Technical Note

Second Response to LLFA Comments

Wickhurst Green, Broadbridge Heath, West Sussex

Project Number: 24184
Doc Number: 24184-MA-XX-XX-TN-D-0003
Prepared for: Vistry South East

Table 2.1 Compliance with National Standards for SuDS

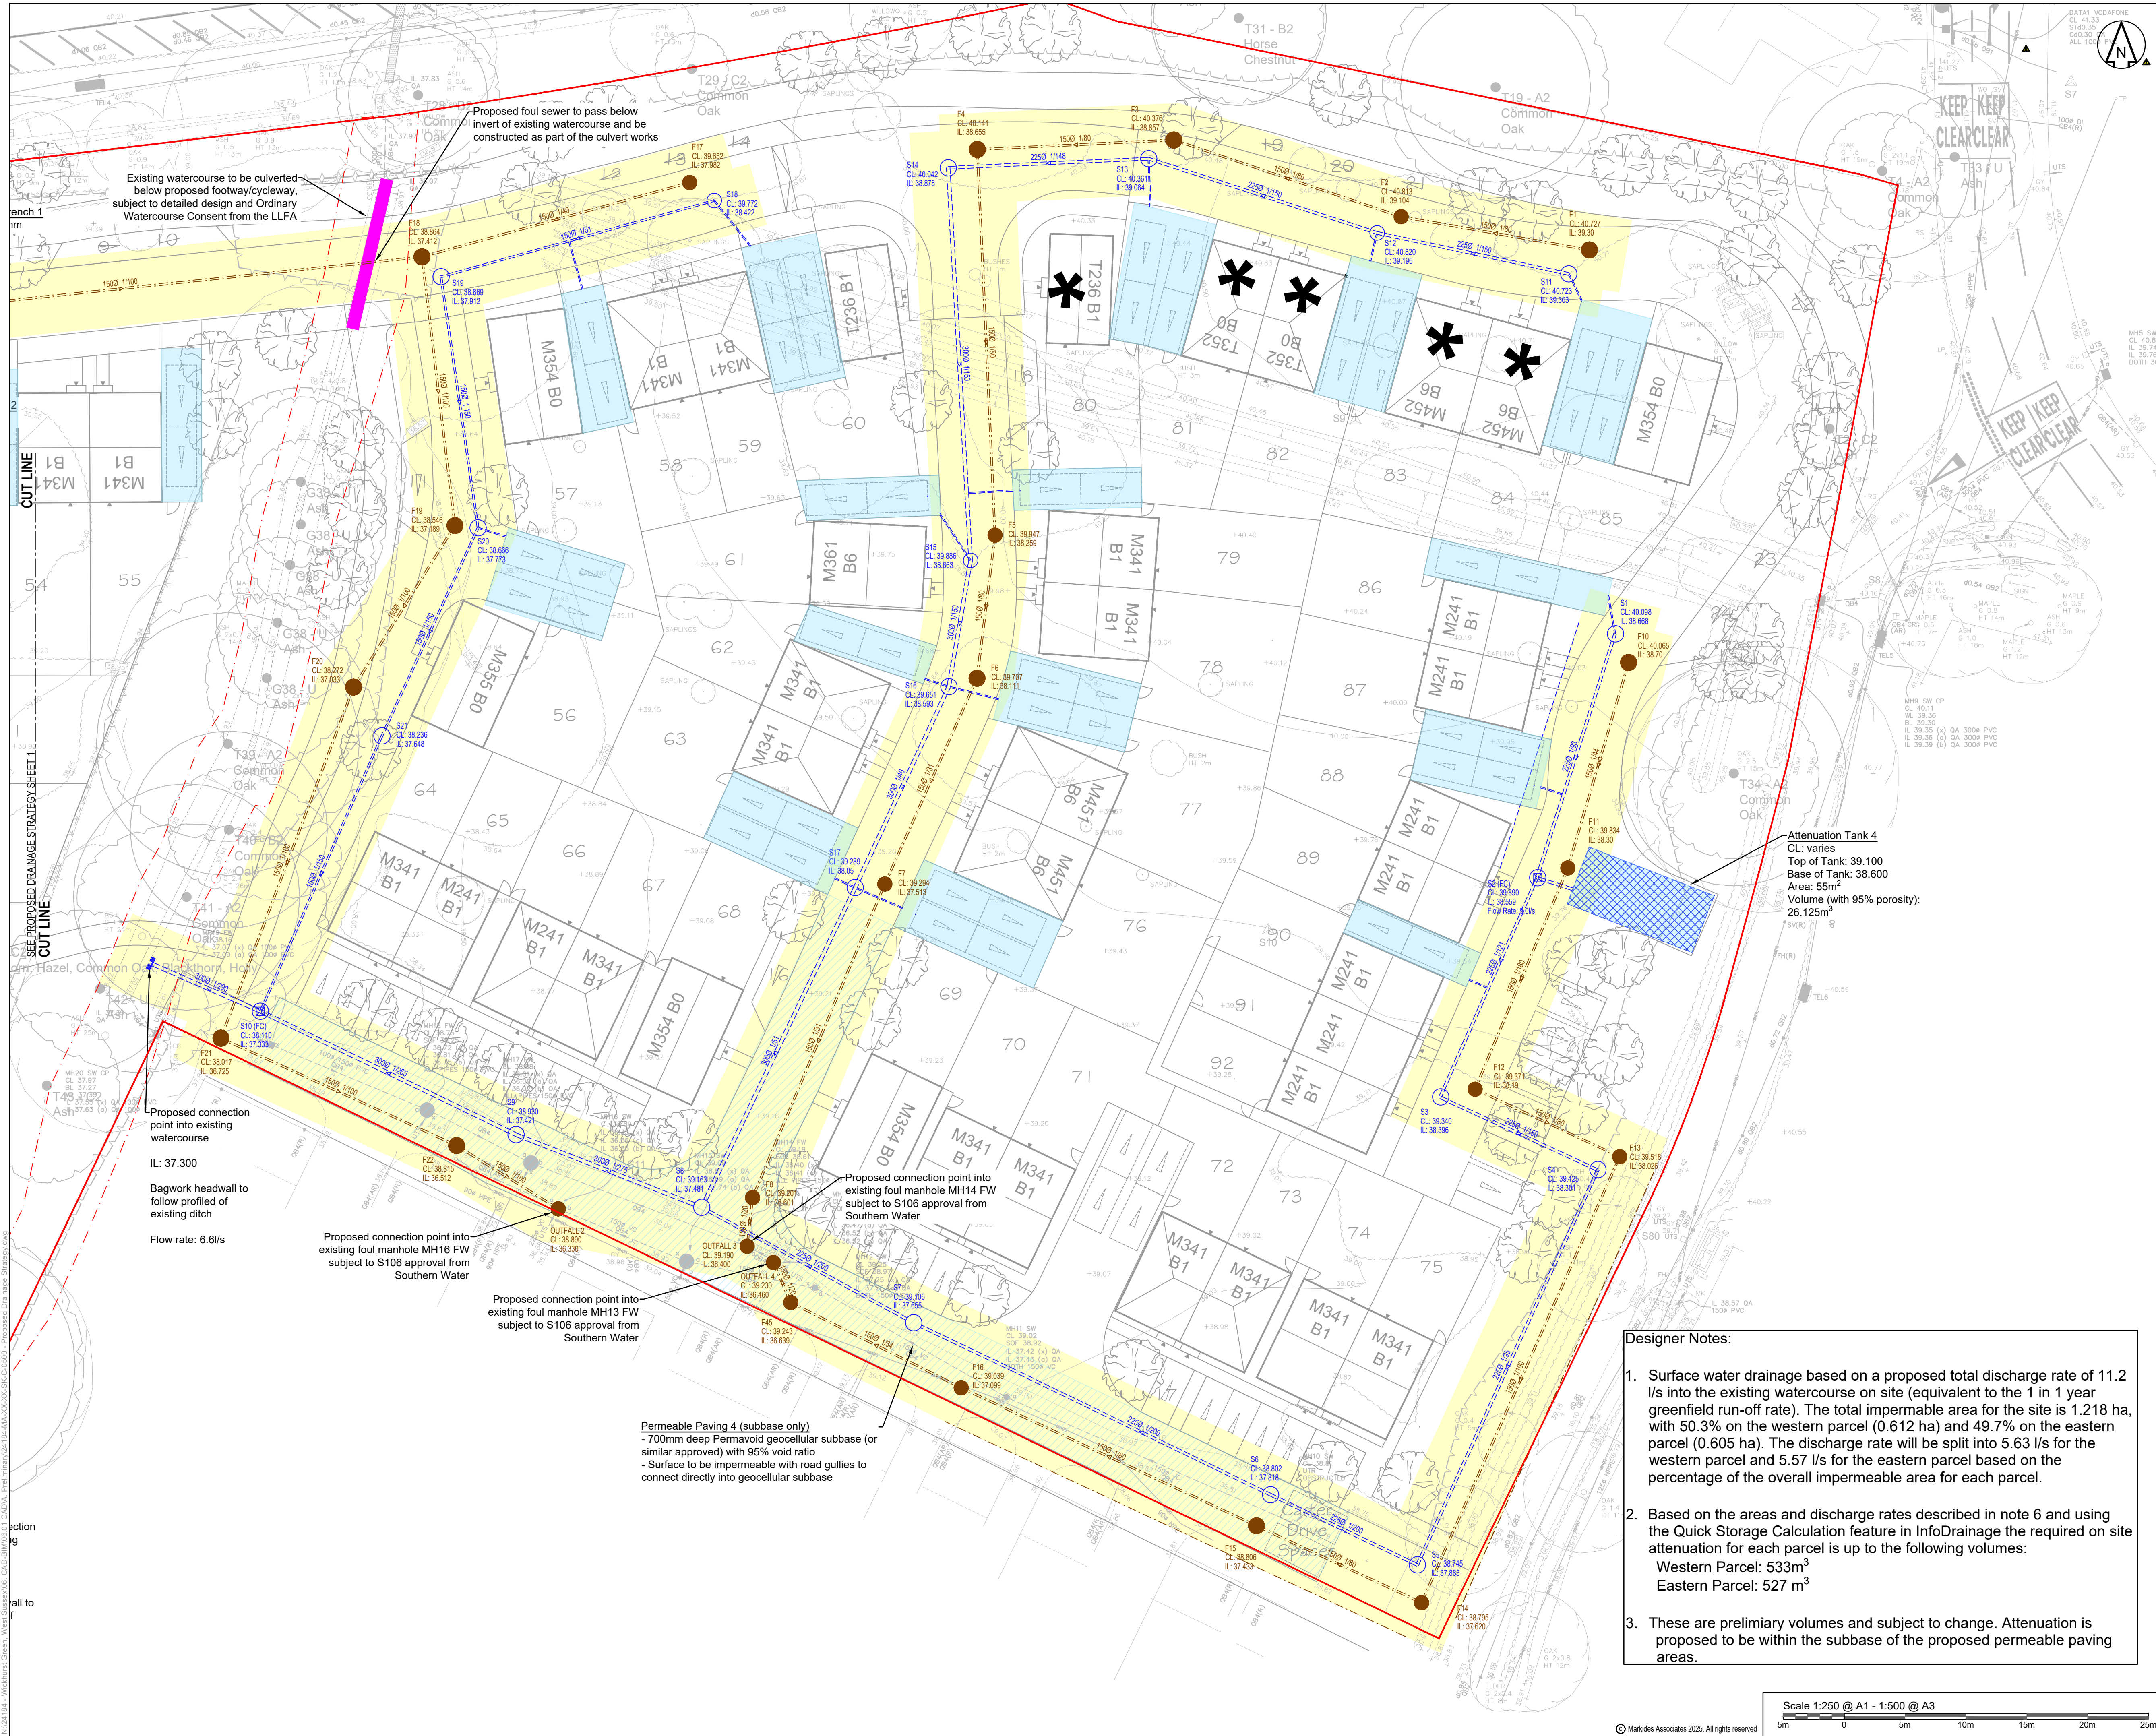
We disagree with section 2.3 of the Technical Note Surface Water Drainage: Response to LLFA Comments. We believe there are opportunities to increase the use of interception in the drainage strategy. As stated in the Technical Note, the application currently does not follow

the National Standards for SuDS as the SuDS Approach is not being followed. SuDS can be designed to fit within constrained sites and have been at other sites with similar densities and geology within the county as well as country.

As raised in pre-application advice as well as our previous comments, we'd encourage the use of source control SuDS instead of traditional piped, underground systems.

2.3.1 Although the design aims to comply fully with the National Standards for SuDS, it is recognised that certain constraints have prevented full compliance with all standards. The Standards acknowledge that there may be specific site or development conditions under which it is not possible to achieve full compliance. In such cases, the opportunity to meet the standard should be maximised, and justification provided for any departure, to be agreed in consultation with the approving body.

2.3.2 Table 2 below summarises how the proposed drainage strategy complies with the National Standards for SuDS.

Standard	Standard Description	Compliance Summary	Status
1	Run-off destinations	Discharge hierarchy followed	Met
2	Management of everyday rainfall (interception)	Maximised as far as possible within site constraints	Minor Shortfall
3	Management of extreme rainfall and flooding	Surface water runoff for the 1% AEP event is controlled to greenfield rates; flooding contained within the system for all events up to and including the 1% AEP + climate change allowance	Met
4	Water quality	Pollution mitigation achieved through SuDS components and network design	Met
5	Amenity	Maximised through inclusion of the attenuation basin, which provides amenity value	Met
6	Biodiversity	Maximised through inclusion of the attenuation basin, which contributes to biodiversity enhancement	Met
7	Design for construction, operation, and maintenance	Achieved through design coordination; Maintenance and Management Plan provided	Met
